LUCKNOW METRO RAIL CORPORATION LIMITED

LMRC/CE/CONTRACT/LKSG-02/2017-18

Subject: - Addendum-1 & Reply to Pre-bid queries for tender LKSG-02.

Ref: - Tender LKSG-02: Manufacture, Supply, Installation, Testing And Commissioning of Signage And Graphics for Nine Elevated Stations (from K.D. Singh Babu Stadium Station To Munshipulia + Amausi Station) and four Underground Stations (Hussainganj, Sachivalaya, Hazratganj and CCS Airport Station) on N-S Corridor of Lucknow Metro Rail Project.

3D View

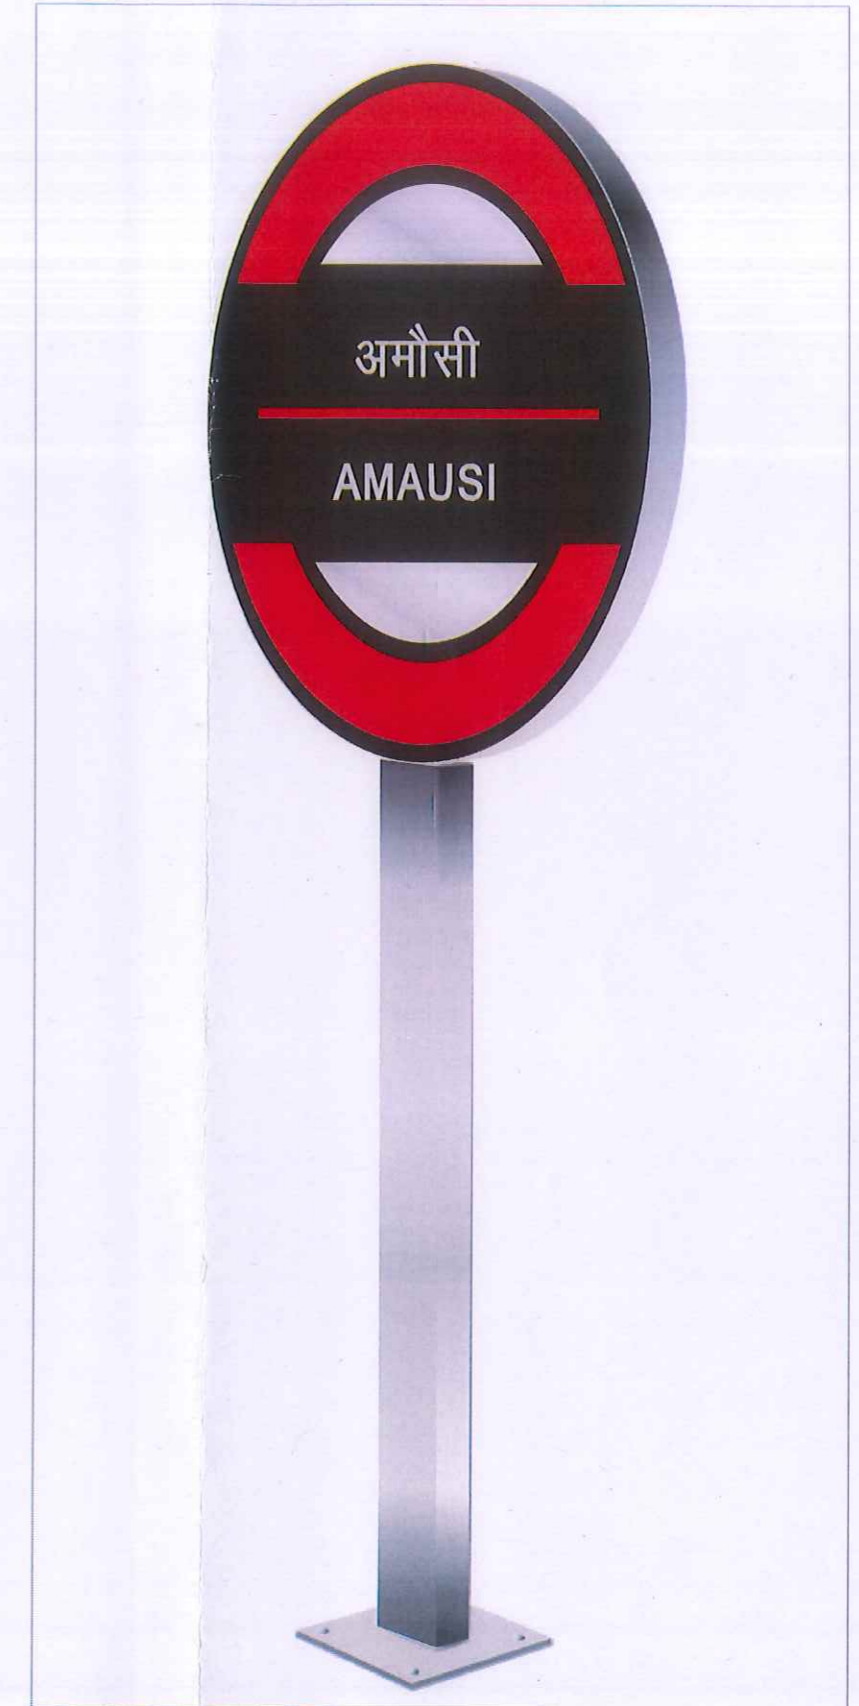
12.11	1200 mm X 1800 mm	NIL-FAC-FP12	Nos	13	₹ 121,390	₹ 1,578,070
12.12	900 mm diameter lollipop type <u>with SS Frame & Support structure complete as per drawing attached as Annexure-6 of Addendum-1.</u>	NIL-FAC-FP13	Nos	104	₹ 106,804	₹ 11,107,616
